DRC-2022-000685

MEMORANDUM

SUBJECT: Review of the Energy Fuels Resources (USA) Inc. (EFR), White Mesa Uranium Mill, Blanding, Utah September 7, 2021, Source Assessment Report for Uranium in Monitoring Well MW-29
Ground Water Discharge Permit No. UGW370004 (Permit)

Figure – Fluoride Plot of Historical Data at MW-29 – Decreasing Trend

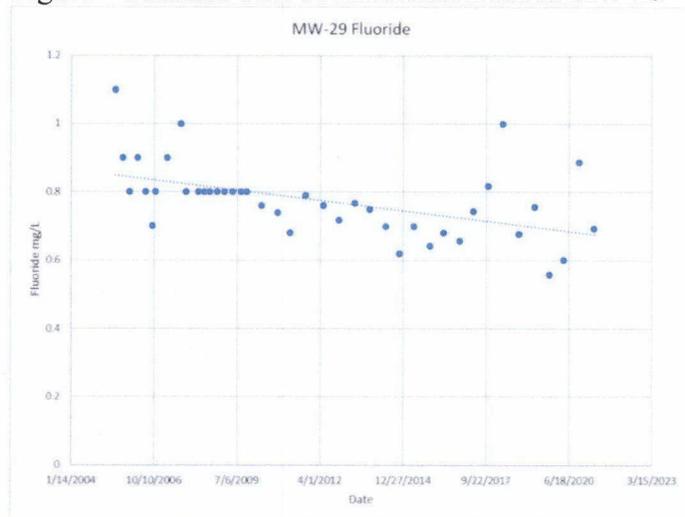
Fluoride is highly concentrated in tailings wastewater and per literature and mill groundwater transport modeling has been shown to be highly mobile in the vadose zone and groundwater beneath the tailing impoundments. Per the figure below, fluoride is showing a decreasing concentration trend in MW-29.
